RHODE ISLAND DEPARTMENT OF TRANSPORTATION

Shippee Bridge No. 307

NOTICE TO PROSPECTIVE BIDDERS

ADDENDUM NO. 2 Prospective bidders and all concerned are hereby notified of the following changes in the Plans, Specifications, Proposal and Distribution of Quantities for this contract. These changes shall be incorporated in the Plans, Specifications, Proposal and Distribution of Quantities, and shall become an integral part of the Contract Documents.

GENERAL PLAN

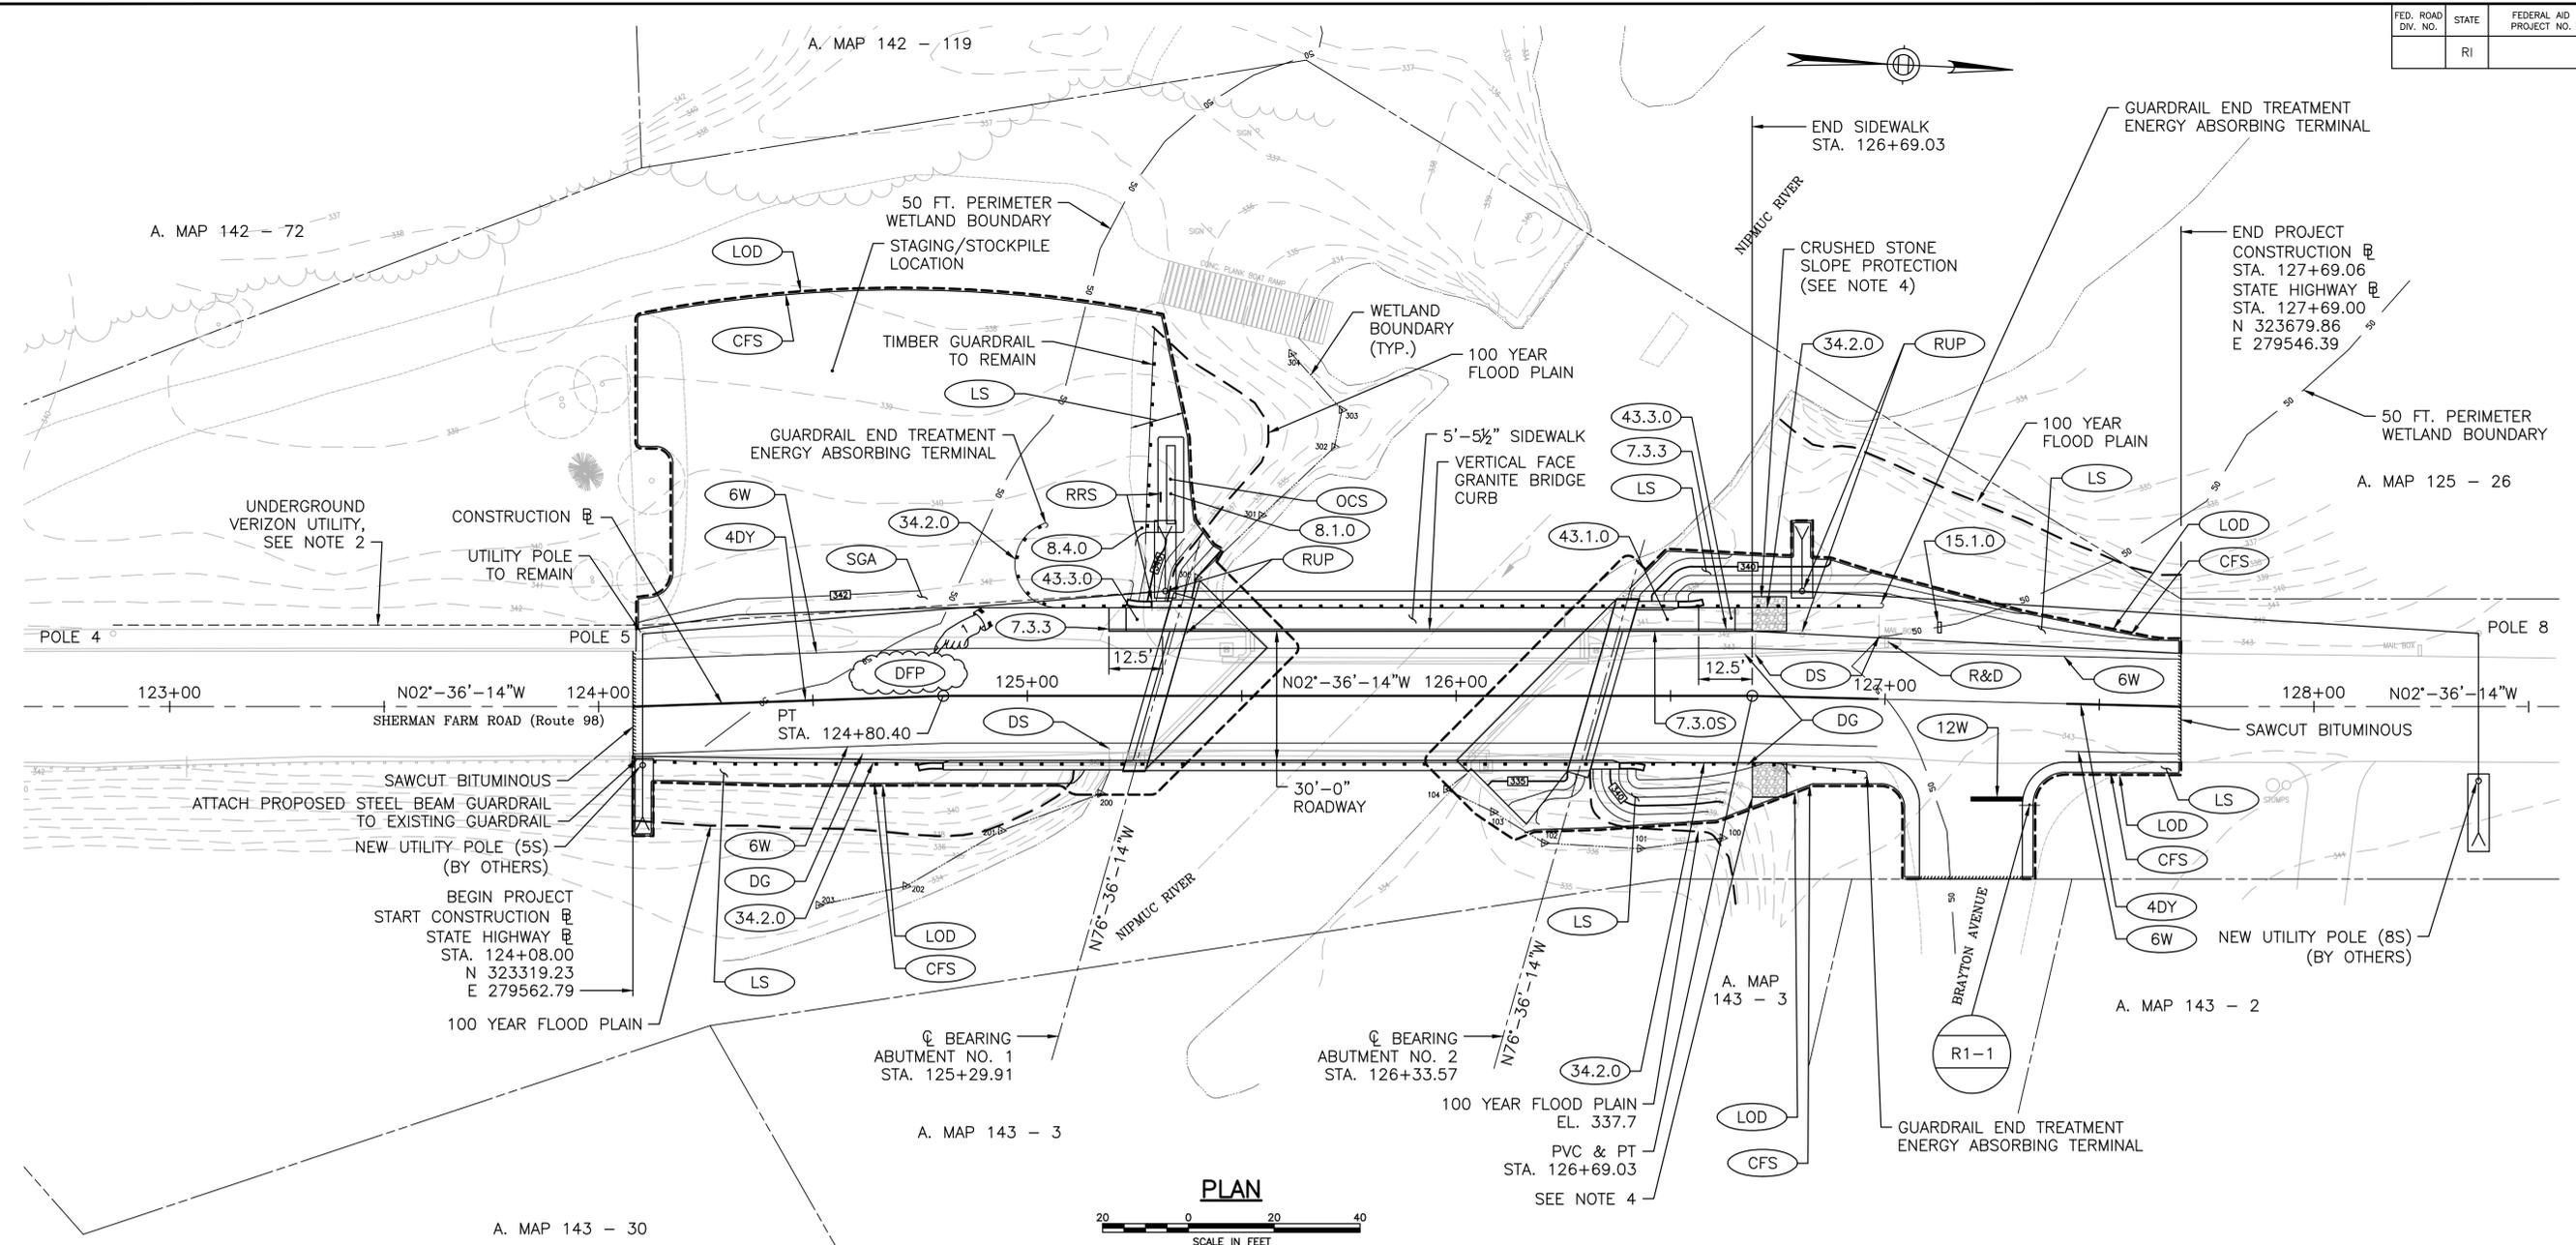
1. General Plan - Volume I - Sheet 8 of 49
 - a. Delete Sheet No. 8 of 49 (General Plan) in its entirety and replace with revised Sheet No. 8 (General Plan) attached to this Addendum No. 2.

RHODE ISLAND DEPARTMENT OF TRANSPORTATION
BRIDGE RECONSTRUCTION SHIPPEE BRIDGE NO. 307 ROUTE 98 OVER NIPMUC RIVER BURRILLVILLE, RHODE ISLAND
ADDENDUM NO. 2 SKETCH NO. 2
CHECKED BY <u>PRIME</u> DATE <u>JAN 2015</u> SCALE _____

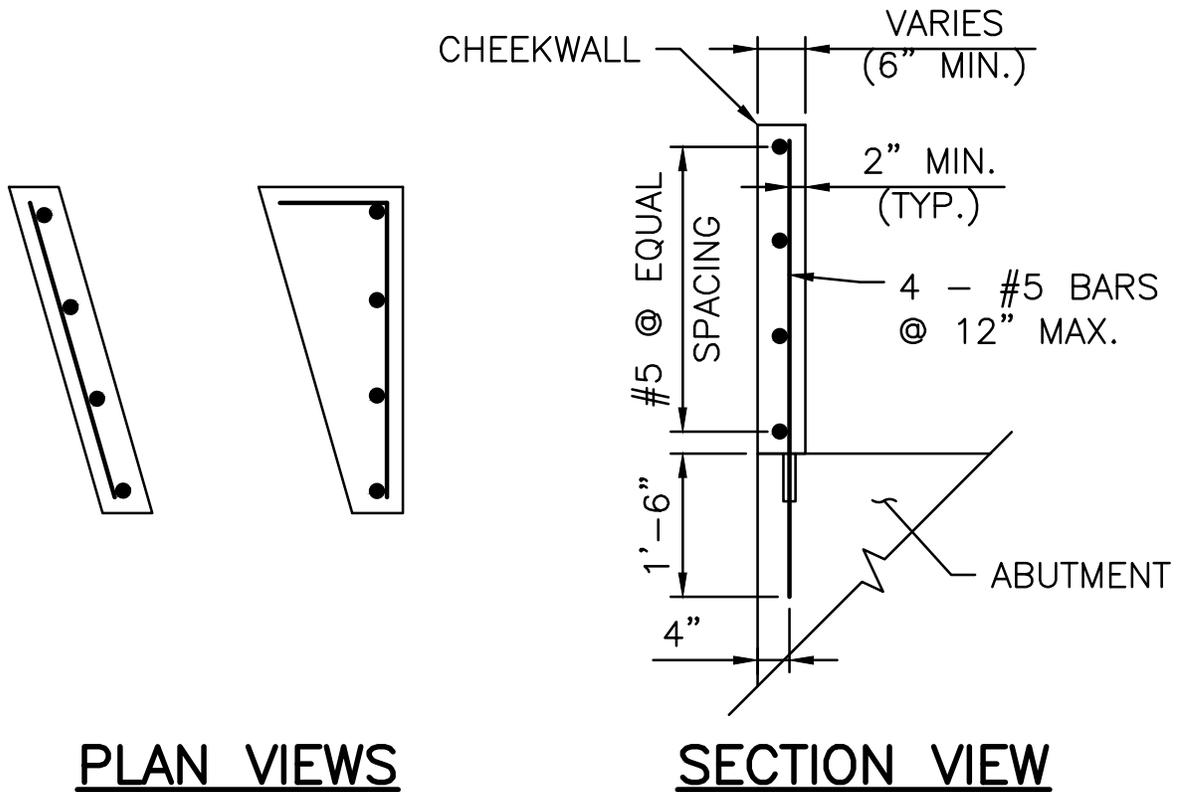
3. Demolition Plan-1 - Volume I - Sheet 16 of 49
 - a. Modify this sheet as shown on Sketch No. 2 attached to this Addendum No. 2. Note No. 5 has been added for clarification of dewatering.

DEMOLITION PLAN-1, SHEET 16 OF 49
ADD NEW NOTE NO. 5, AS FOLLOWS:

5. COST OF DEWATERING TO BE INCLUDED IN ITEM 201.9901, SANDBAG DIKE SYSTEM.
